604123-111717

ADDENDUM NO. 5

**Federal Aid Project Nos. CMQ-003S(390), STP-003S(390) & TAP-003S(390)
Roadway Reconstruction and Related Work along Route 126 (Pond Street)**

Transmitting revisions to the Contract Documents as follows:

ROUTE 126 (POND STREET)			
STATE	FED. AID PROJ. NO.	SHEET NO.	TOTAL SHEETS
MA	CMQ/TAP/STP-0035(390)	19	331
PROJECT FILE NO. 604123		CONSTRUCTION PLANS (4 OF 17)

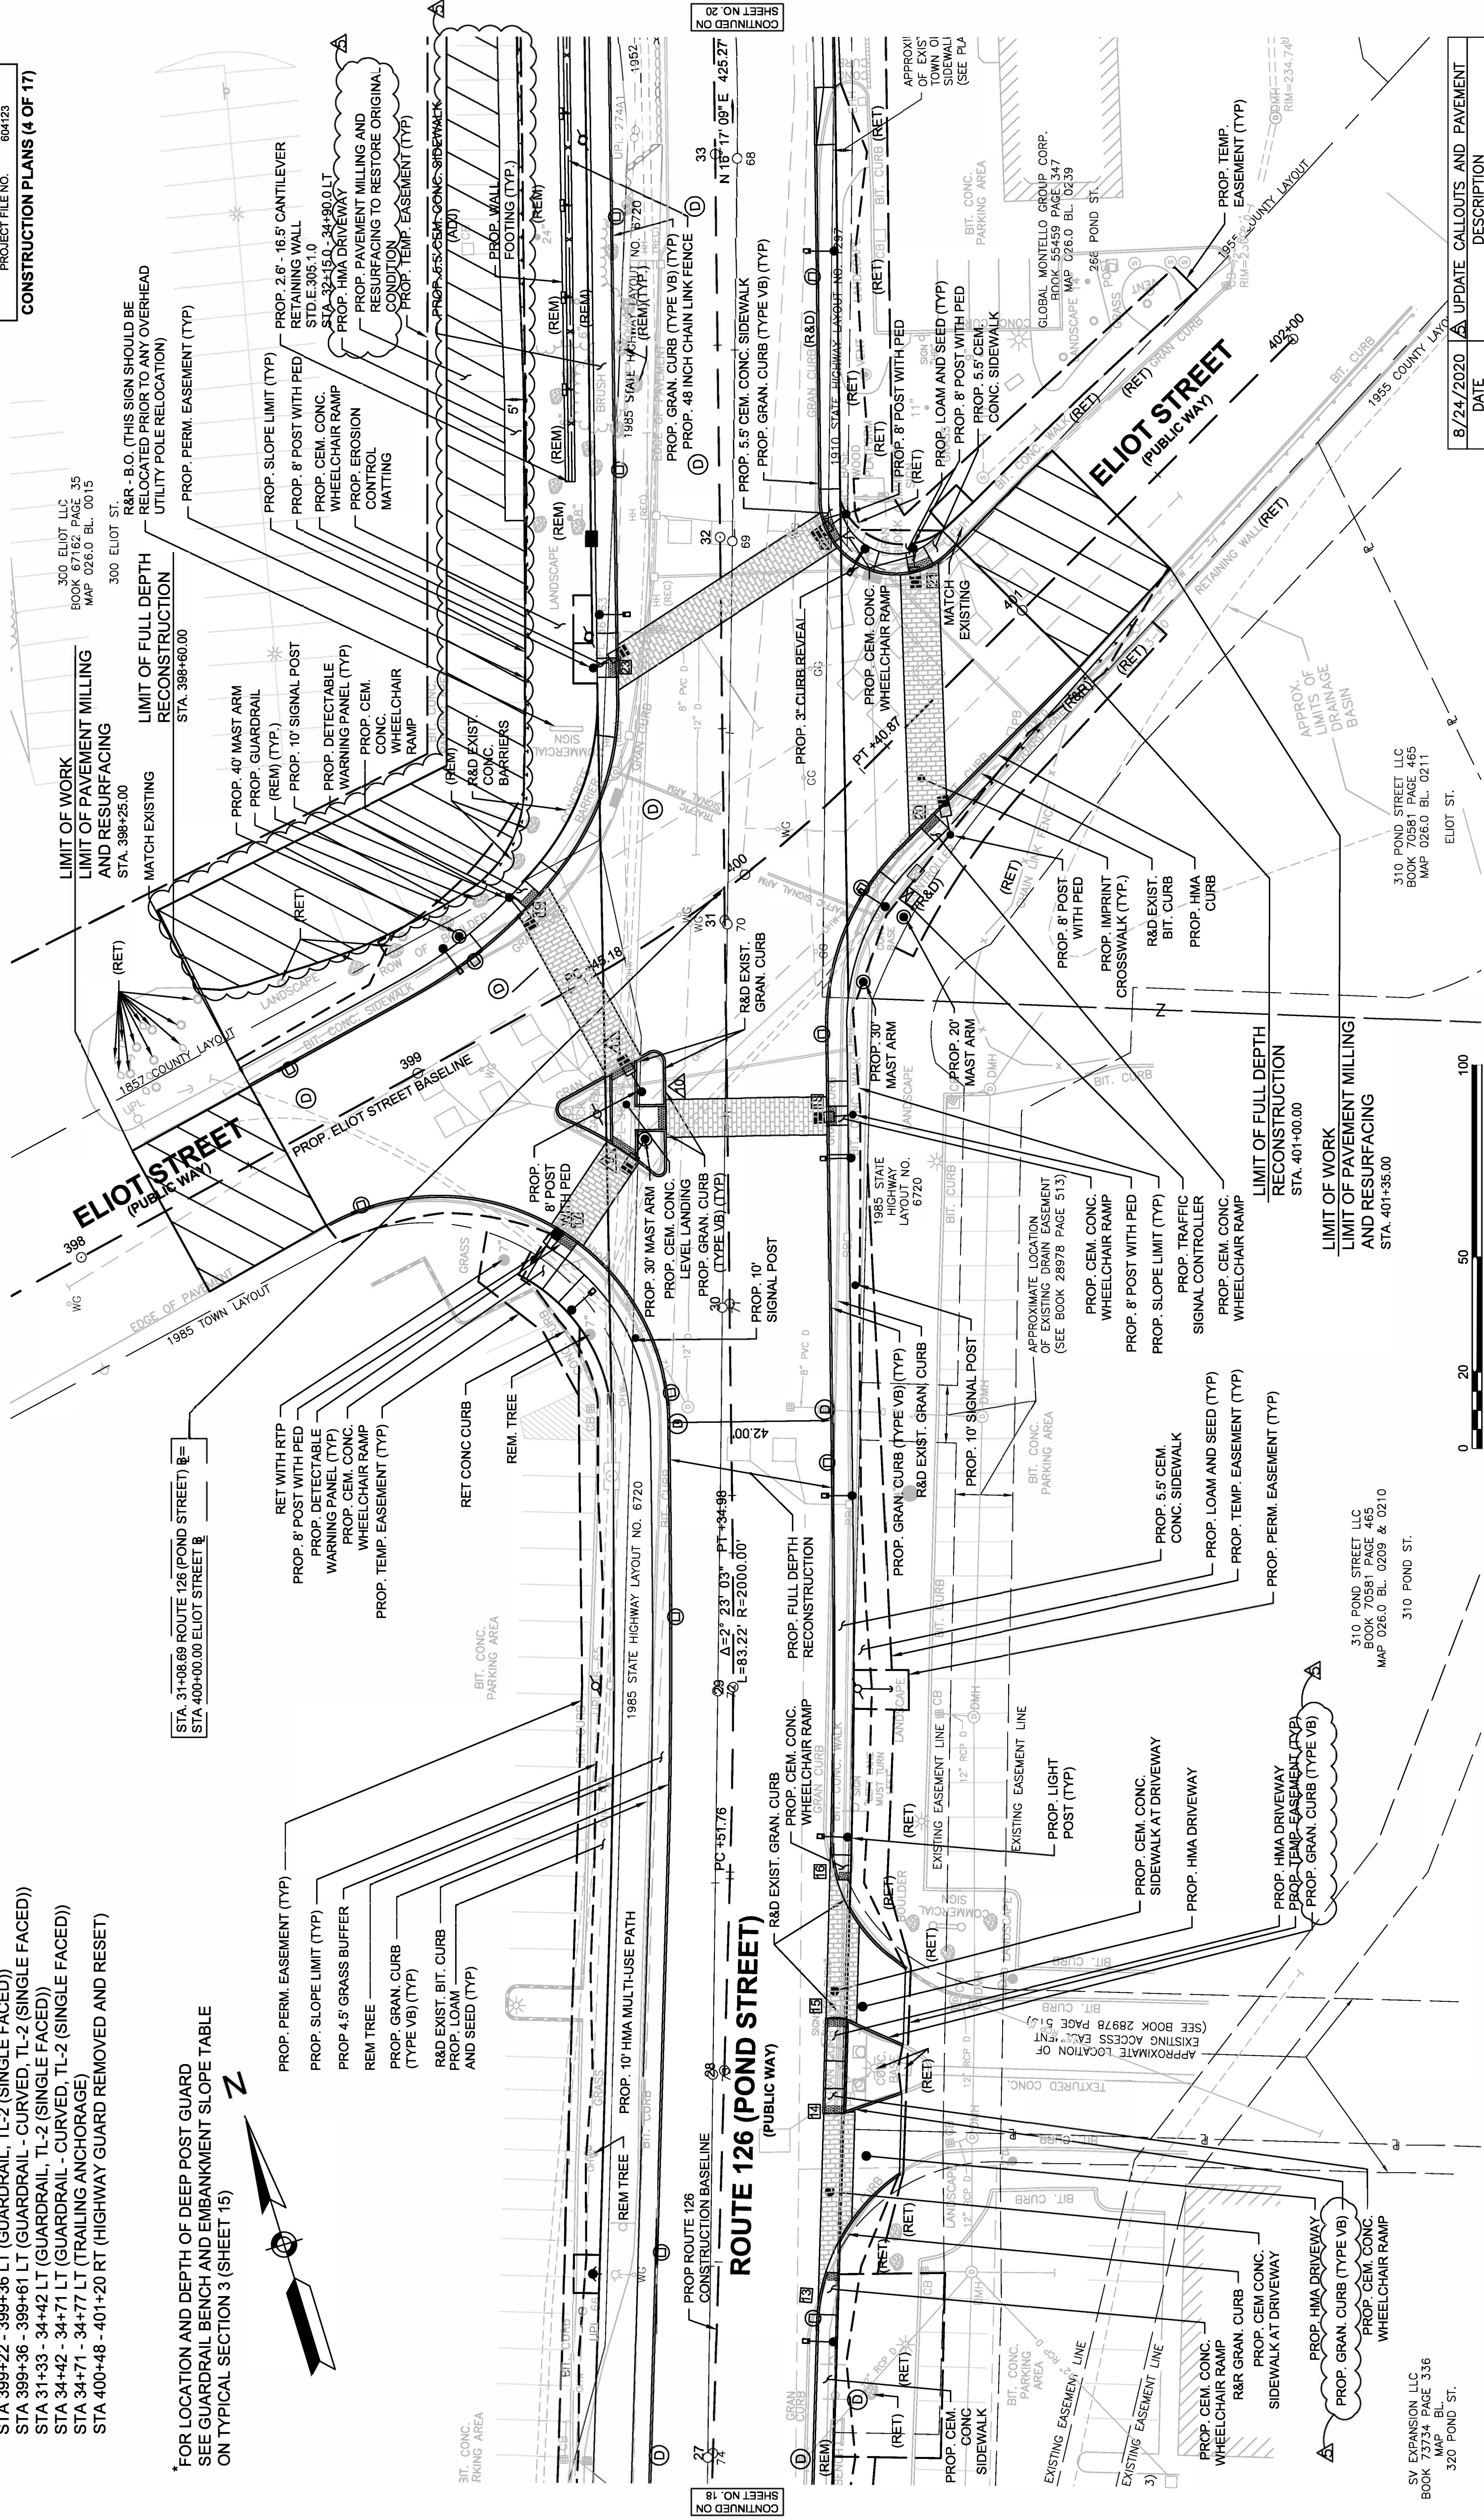
Question #20: The Parking lot behind the retaining wall at Sta. 32+15 – 34+90 Left will likely need to be patched/paved as a result of excavation impacts with the wall, under what item will this HMA be paid for? Confirm it will be constructed as an HMA driveway-2.5" SIC 19.0 & 1.75" of SSC-12.5 and paid under Item 702. Confirm fine grading of the area prior to driveway repair will be paid for under Item 170.

Question #22: Can the parking lot behind the wall within the Temp. Easement shown on plan sheet 19 and 20 be closed during construction to not allow traffic on top of the support of excavation area?

Question #52: On Sheet No. 19, Construction Plans (4 of 17), proposed cement concrete curb is shown. Please add pay item for this work.

Response #20: The repairs to the noted parking lot will be paid under Items 415.3, 450.23 and 451. See revised sheets 19, 20, and 97 of 331.

Response #52: See revised Sheet No. 19 of 331.

STATE	FED. AID PROJ. NO.	SHEET NO.	TOTAL SHEETS
MA	CMQ/TAP/STP-003S(390)	98	331
PROJECT FILE NO.			604123

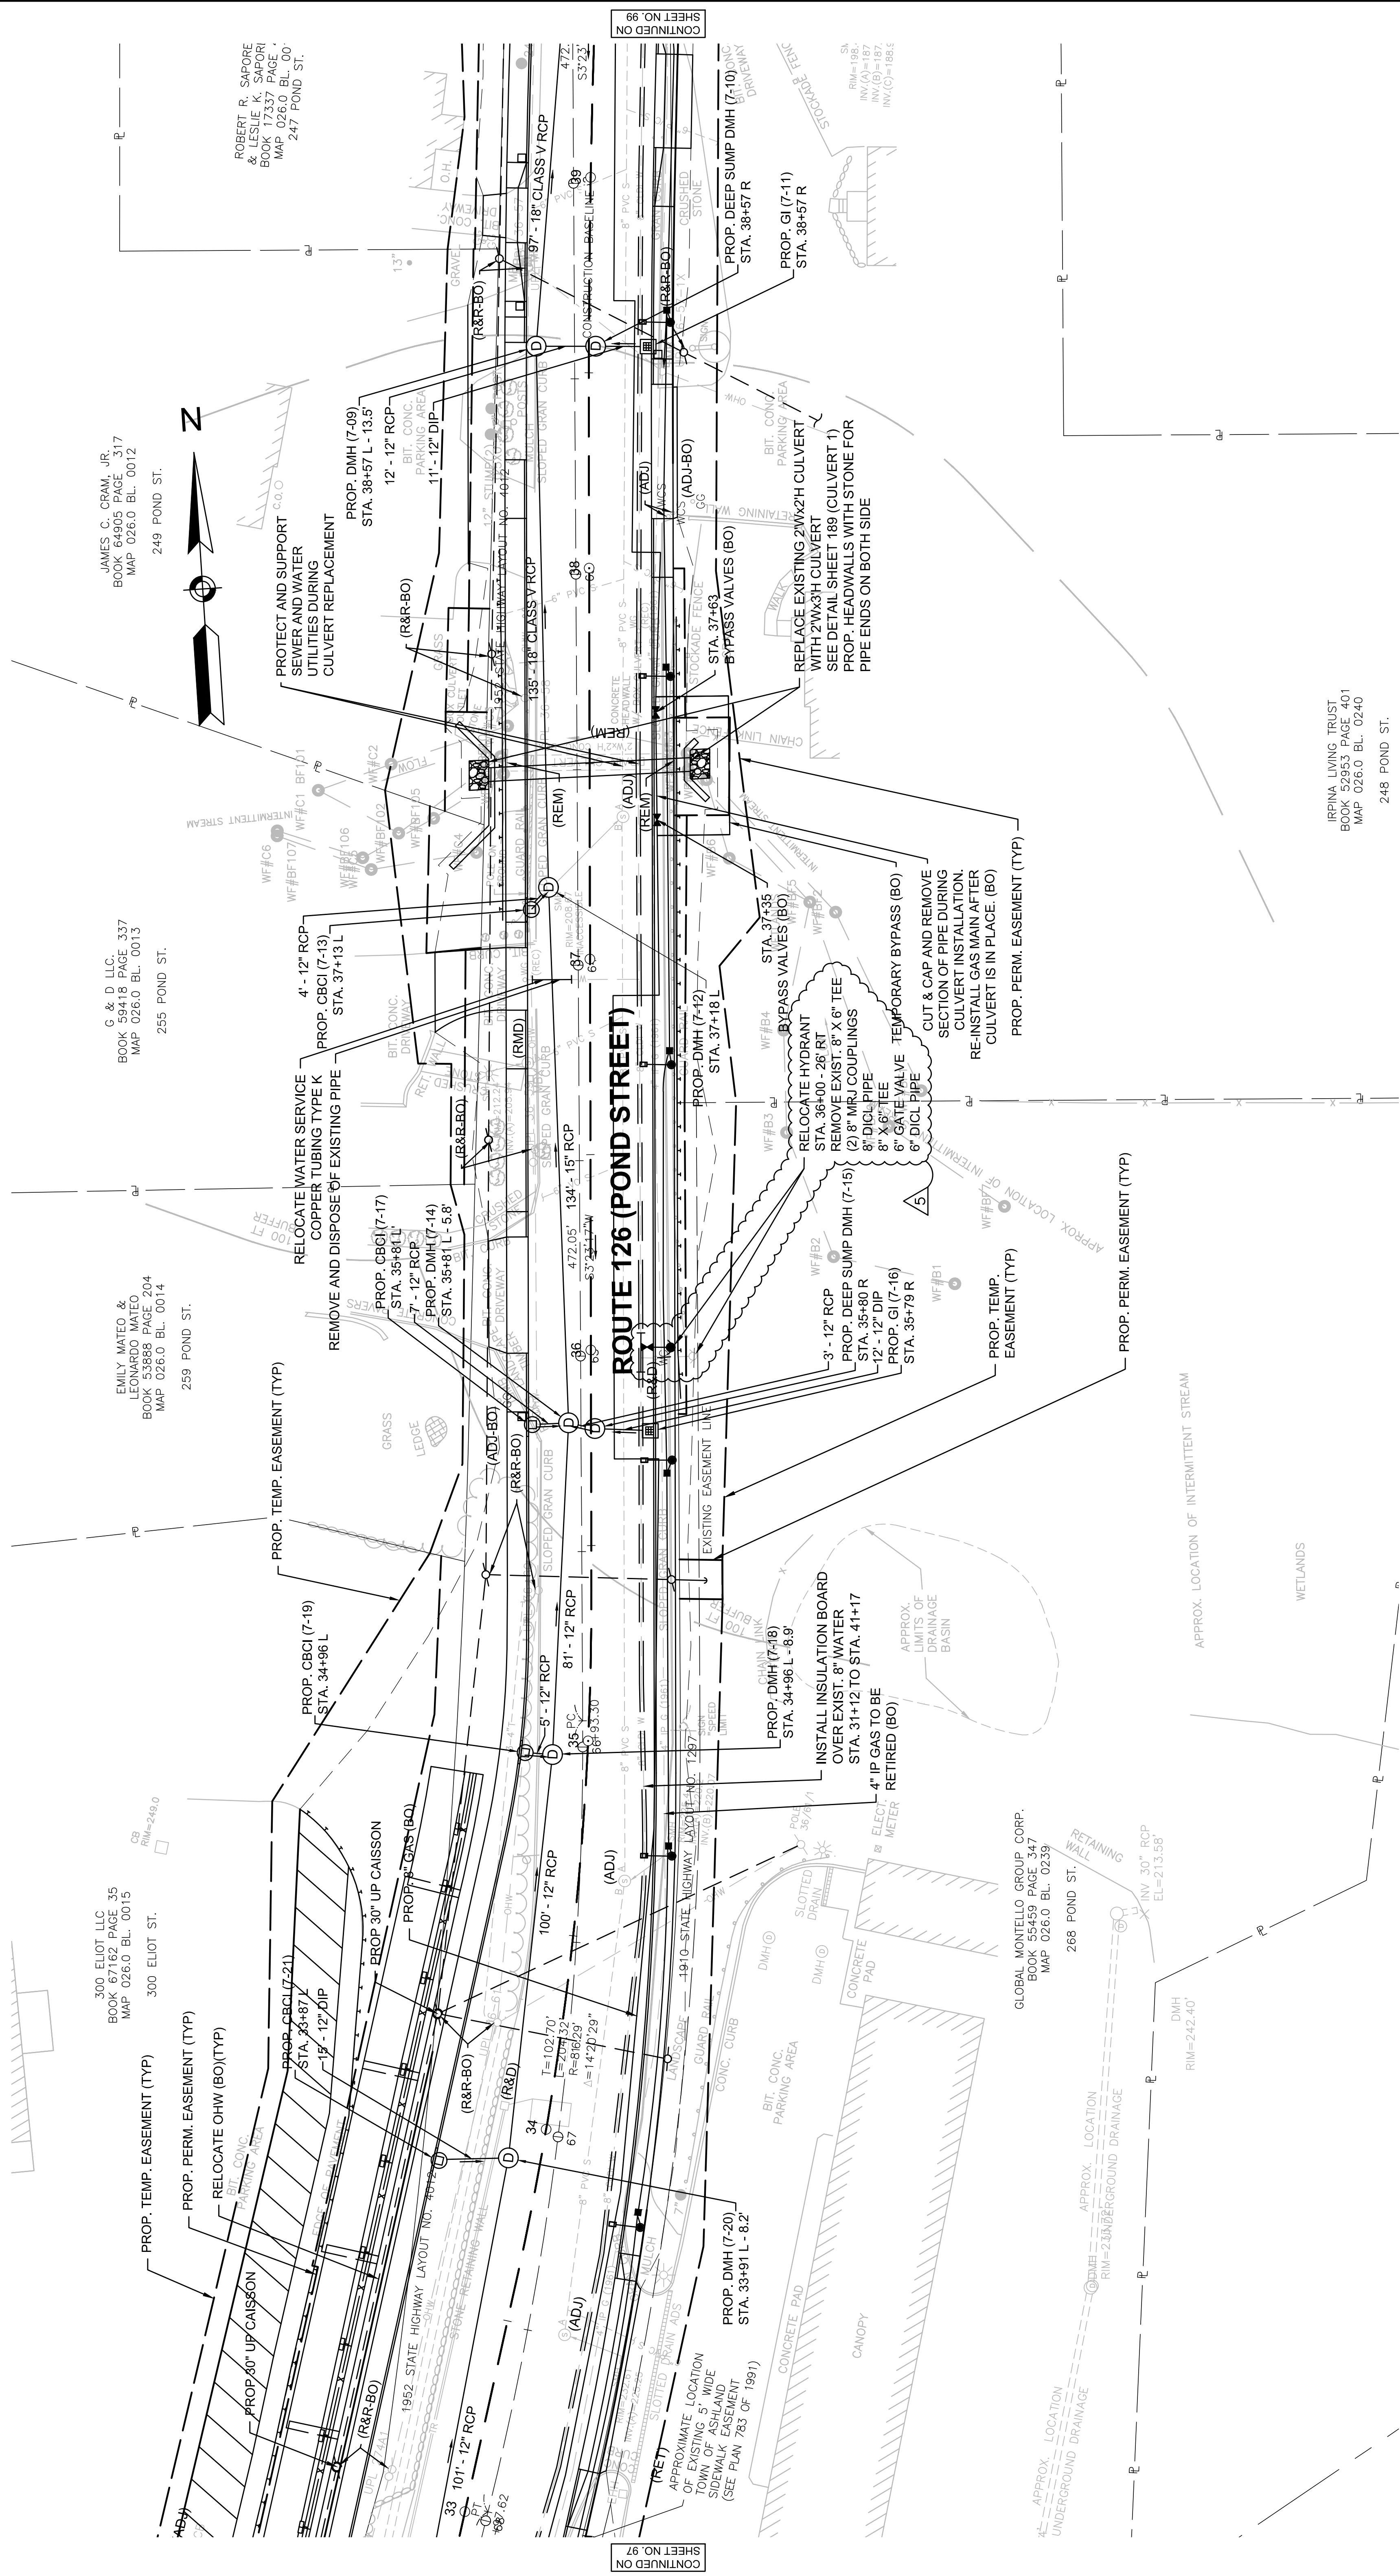
Question #53: 6"x6" tapping sleeves are proposed at relocate hydrant locations on Rte. 126, Sta.'s 78+68 & 96+58. There is no bid item for 6"x6" tapping sleeves.

Response #53: See revised Sheets 98, 100, 101, 103, 105, 106, 107, 108, and 109 of 331 and revised page B00420-12.
